**SAFETY EVALUATION REPORT  
FOR RENEWAL OF  
SOURCE MATERIAL LICENSE NO. SUA-1534**

**CROW BUTTE RESOURCES, INC.  
CROW BUTTE URANIUM PROJECT  
DAWES COUNTY, NEBRASKA**

**DOCKET NO. 40-8943**

Re: Docket No. 40-8943  
License No. SUA-1534  
Response to Request for Additional Information - License Renewal

Figure 4-1. Proposed survey and sampling locations (CBR, 1997d)

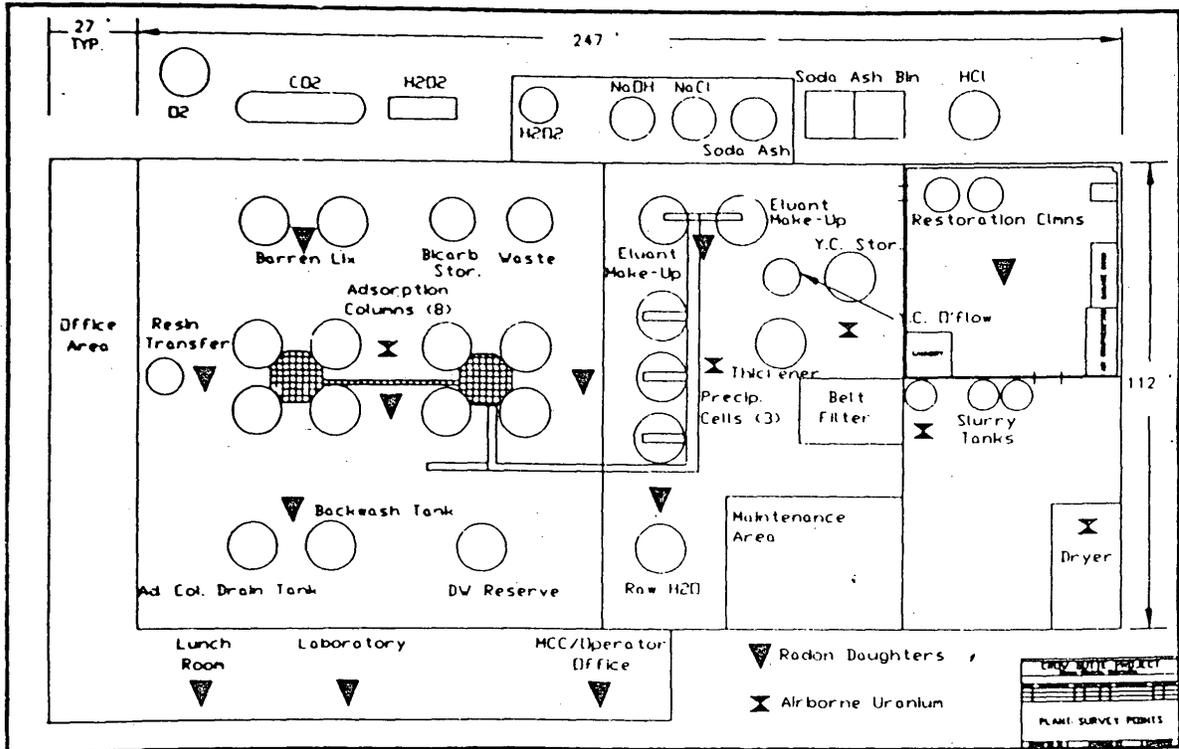
Area airborne sampling for uranium particulates is conducted, on a monthly basis, at the four locations shown in Figure 4-1. In addition, samples are taken in the dryer room during dryer operations and when RWPs are issued for this area. Average annual and maximum monthly gross alpha activity results from 1990 to 1996 were below 25 percent of the Maximum Permissible Concentration or the Derived Air Concentration (DAC) (after January 1, 1994) specified in 10 CFR Part 20.

CBR conducts radon daughter surveys on a monthly basis at 11 in-plant sampling locations (Figure 4-1) and at an additional location in the reverse osmosis building. During commercial operations, the action level of 0.08 WL has been exceeded on several occasions. CBR conducted appropriate investigations and corrective actions to address these situations. Average monthly and annual radon daughter activities during the period of commercial operations have been less than 25 percent of the maximum permissible exposure limit or the DAC (after January 1, 1994).

CBR conducts radon daughter surveys on a monthly basis at the 11 in-plant sampling locations shown in Figure 4-1, and at an additional location in the reverse osmosis building. Samples are collected using a low-volume air pump and analyzed with an alpha scaler using the Modified Kusnetz method (ANSI-N 13.8-1973). The samplers are calibrated every six months. CBR has established an action level of 25 percent of the DAC, or 0.08 Working Levels, for the in-plant locations. Survey results in excess of the action level will result in an investigation of the cause and an increase of sampling frequency to weekly until radon daughter levels do not exceed the action level for four consecutive weeks.

9. In-plant radiological monitoring for airborne uranium and radon daughters shall be conducted at the locations shown in Figure 5.7-1 in the approved license application.

Figure 5.7-1: Proposed Survey and Sampling Locations

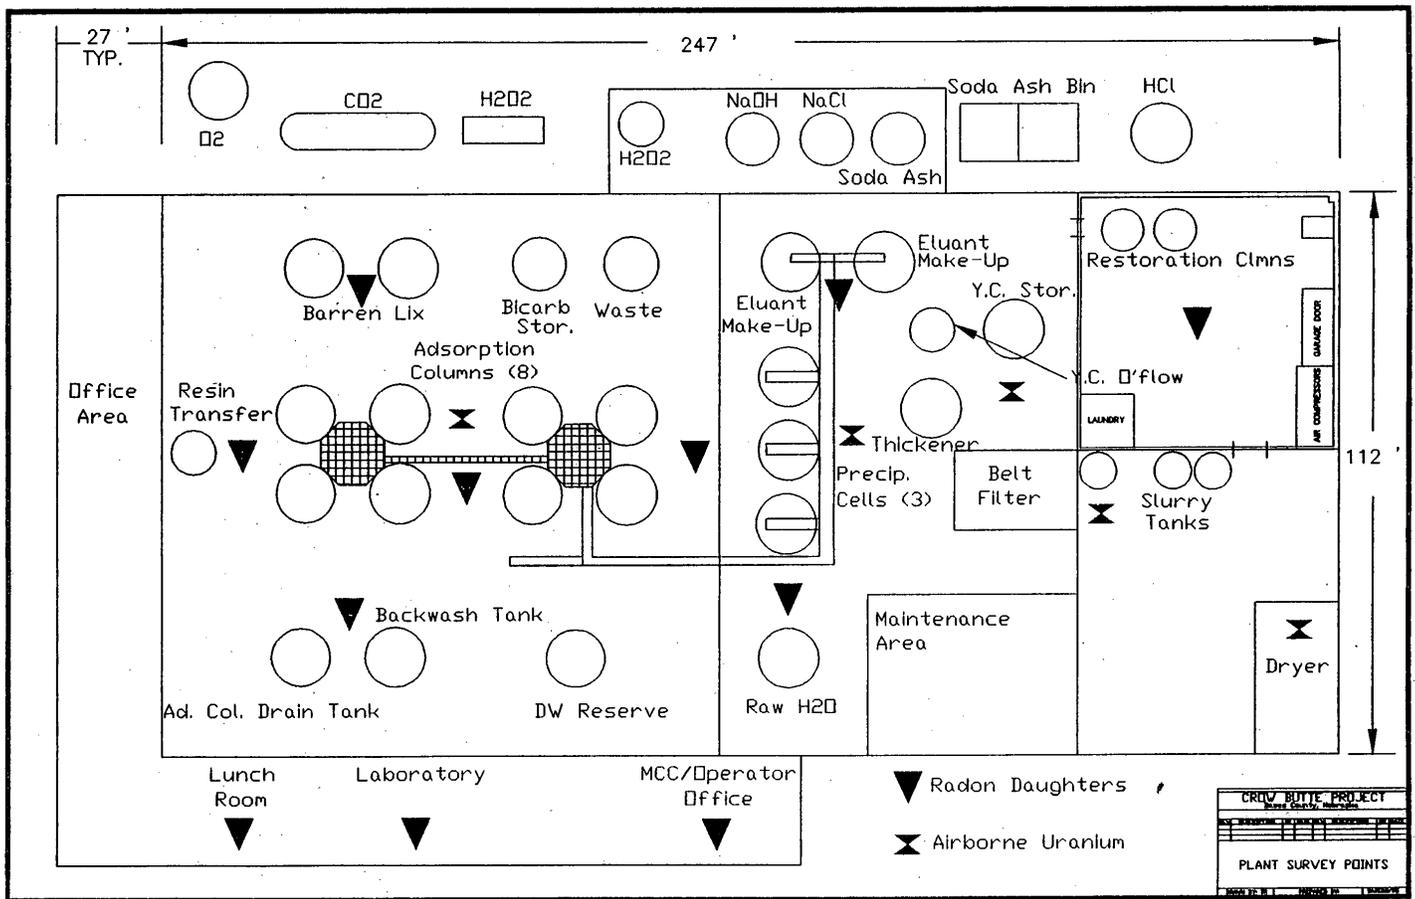
**Request 1.** *Technical support should be provided for proposed changes to the in-plant monitoring programs.*

1.) The radon daughter sampling location shown in Figure 5.7-1 in the Dryer area has been deleted under Amendment Number 33 of SUA-1534. The request to eliminate this location was submitted on October 5, 1995.

2.) A radon daughter monitoring location near the Raw Water tank was inadvertently left out of Figure 5.7-1 during preparation of the LRA. A revised Figure 5.7-1 with the noted changes is attached for inclusion with the LRA. CBR proposes no change in radon daughter sampling locations from the current program.

**Response:** CBR has not proposed any change to the in-plant monitoring programs or monitoring locations noted in the text accompanying this Request for additional information. In order to provide clarification, CBR is providing the following information for each of the three monitoring programs noted in Request 1.
